Executive Director's Recommendation

Commission Meeting: July 13, 2017

PROJECT Building Exterior, Vestibules and Site Improvements – Cladding Replacement National Air and Space Museum Independence Avenue at 6th Street, SW Washington, DC	NCPC FILE NUMBER 7585
SUBMITTED BY Smithsonian Institution	NCPC MAP FILE NUMBER 1.41(38.00)44574
REVIEW AUTHORITY Federal Projects in the District per 40 U.S.C. § 8722(b)(1) and (d)	APPLICANT'S REQUEST Approval of comments on revised concept design
	PROPOSED ACTION Approve comments on revised concept design
	ACTION ITEM TYPE Staff Presentation

Smithsonian National Air and Space Museum Building Exterior, Vestibules and Site Improvements - Cladding Replacement

Colonial Rose Mockup

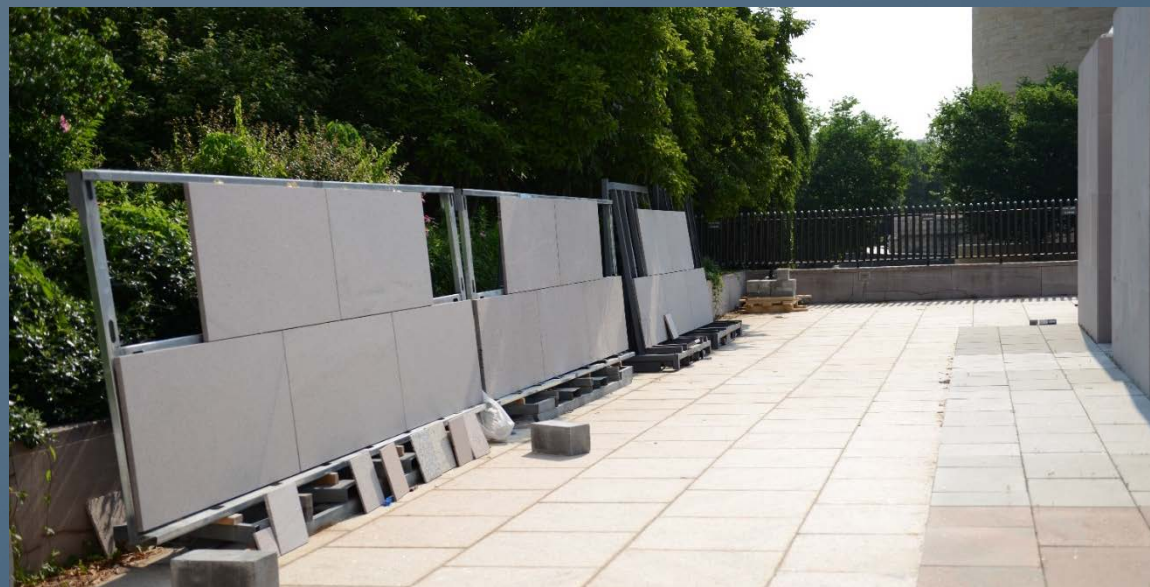
During the site visit staff noted that Colonial Rose Granite appeared too monochromatic and would result in monolithic facades if selected. The stone cladding needs variety to subtly articulate the facades. The SI recently installed additional mock-up panels of Colonial Rose granite. The new stones show the wider range of color and veining available.

Upon consideration of the Smithsonian's findings, supports Colonial Rose as the preferred cladding alternative and strongly encourages increasing the percentage of stone panels with color variation and horizontal pattern in the design specifications to avoid a monolithic facade. If uniform panels must be used, disperse and minimize its use, increase tonal variation and avoid juxtaposing similar panels to achieve the randomness of the original façade.

Requests that the Smithsonian continue to consult with NCPC staff on any future mockup of Colonial Rose to test different combinations of color pattern and veining, as well as the glazing mockup.
